**DISTRICT OF LILLOOET
WATER SOURCE REPLACEMENT
CONTRACT #4
FILTRATION TREATMENT PLANT**

**CONTRACT DOCUMENTS AND SPECIFICATIONS
ADDENDUM #4**

**WATER SOURCE REPLACEMENT
CONTRACT #4
ELECTRICAL ROOM EXPANSION DETAILS**

AD1
534-285

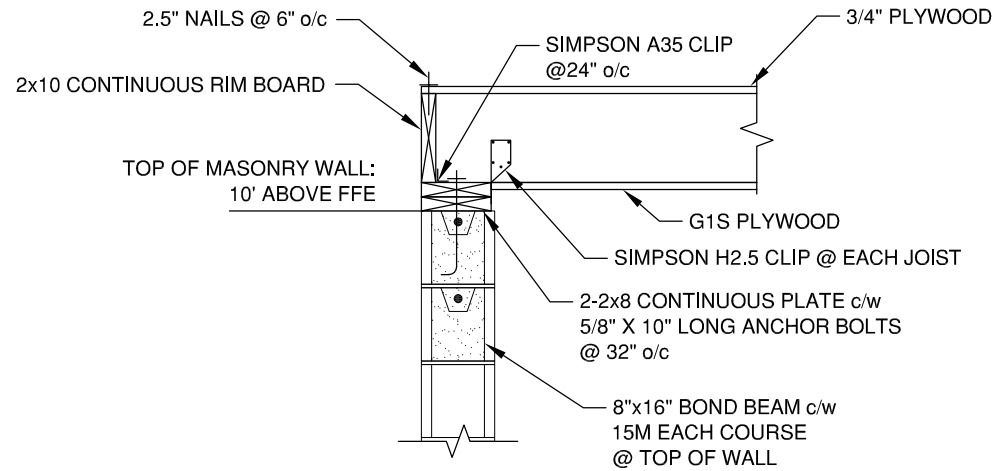
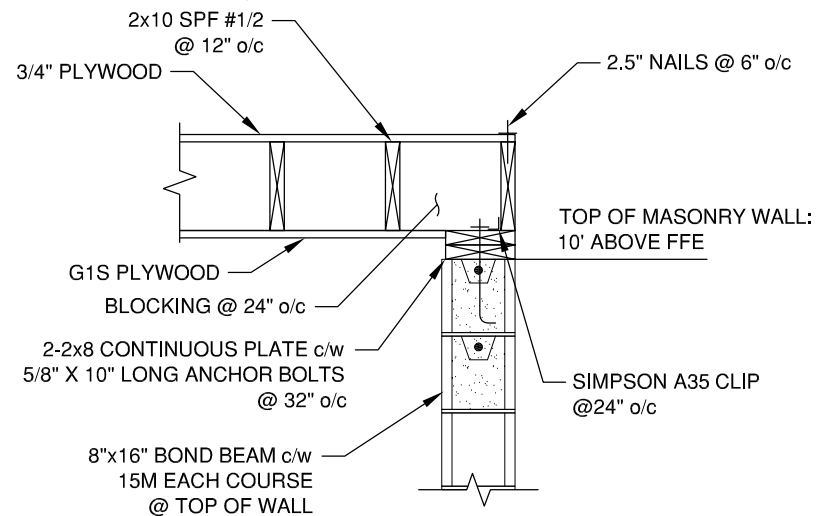
- (1) Firestone Two ply SBS Roofing Products have been approved as equals to products specified in Section 07 52 00.
- (2) CGC's Securock Gypsum Fiber Roof Board has been approved as equal to products specified in Section 07 52 00.
 - a. Products must be installed per manufacturer's requirements.
- (3) 3M Self Adhered Air and Vapour Barrier Membrane 3015 has been approved as equal to products specified in Section 07 27 00.
- (4) Westform Metals Prolok 12 has been approved as an equal to Vic West Prestige Panel.
- (5) The expansion of the existing electrical room will require the contractor to match existing construction. Details are provided on attached drawing 534-285-AD1.
- (6) Rosemount has been approved for Sections 40 91 20 and 40 91 24.

NOTE: INTERIOR TO BE PAINTED TO MATCH EXISTING ELECTRICAL ROOM
